PROBLEM REPORT PR-1032

STEREO IMPACT FM2 IDPU Cold Start 2

2005-01-14

IDPU LVPS schematic, digital supply section. C46 is the suspect part.

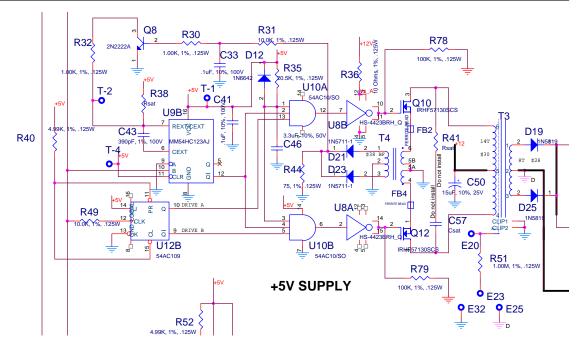
A solid tantalum capacitor is polarized, and really should not be operated with reversed voltage. A reversed voltage "eats" the dielectric and causes increasing leakage resistance, which causes localized heating, which accelerates the destruction of the dielectric (etc): the "end game" is for the resistance to drop percipitiously to (order of magnitude) an ohm.

Applying less than 15% of the rated voltage (reversed) will typically never result in a short. Again, temperature matters: operating at the high-temperature limit AND at 15% of rated (reversed) voltage would be ill-advised.

The rules call for derating these caps to 50% of their military rating. So you put a 20V cap into a 10V circuit. The downside of this is that the cap will support a reversed voltage for some hours to weeks --- you can hope that the testing program will "surface" the failure before you launch.

I am puzzled about the "will not short at less than 3 volts" remark, unless this remark applies to caps with rated voltage of 20 volts (note: 3 V is 15% of 20 V). One can procure solid tantalum caps rated at (say) 5 V, and running such a cap at a reversed 3 V would be expected to short it in a time much less than your mission life. Perhaps the quoted "mil" remark is made in a context in which only caps rated at 20V or more are being used?

If you have a solid tantalum cap that is suspected of misbehaving, then a direct measurement of its capacitance and its leakage is reasonable. If the leakage is high, one can open the cap and carry out an electroplating of its tantalum slog --- deposits of copper mark shorted tantalum grains.
